NOTICE OF ERROR
REPLY

Water right number: 73-84

SRBA Recommendation:

73-84

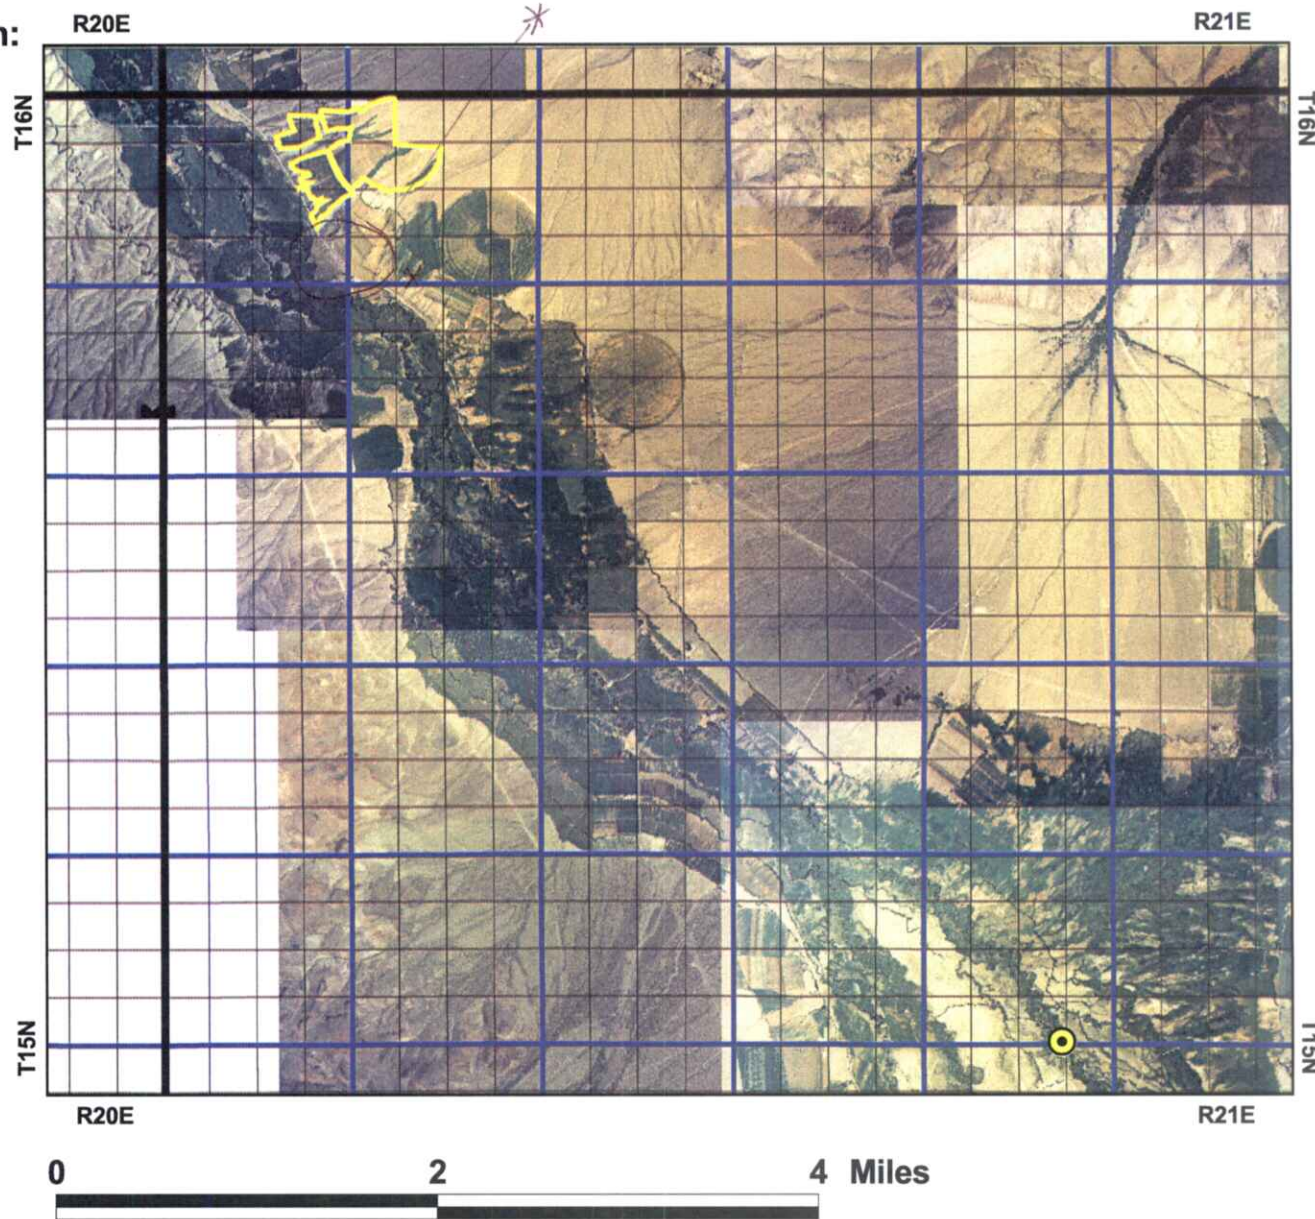
*Water source name is incorrect
irrigated inches is incorrect*

*Water Master and other records identify Big Spring Cr. as
the source - Delivered by Cotter Ditch.
Area circled & starred on map is also irrigated by this right.*

*Source of water is Big Spring Creek
Irrigated acres is 246.2. - According to ASCA map enclosed.*
